1 Products affected

Packaging improvement: New color of the carrier tape.

OGN-SMD						2192	
creation date	created by	release date	released by	notification no.	revision	page	
2013-10-31	dislercy	2013-12-19	dislercy	25389	_	1 of 2

List of affected part numbers

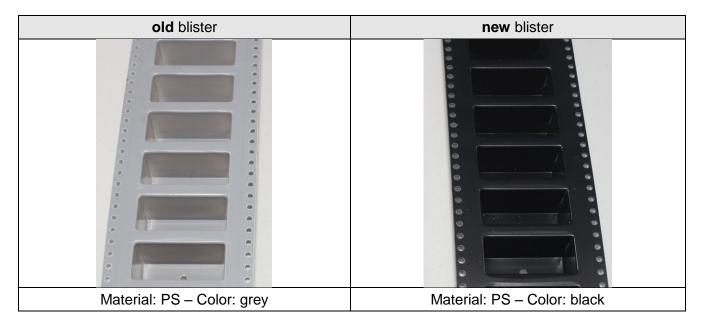
Color change of the carrier tape
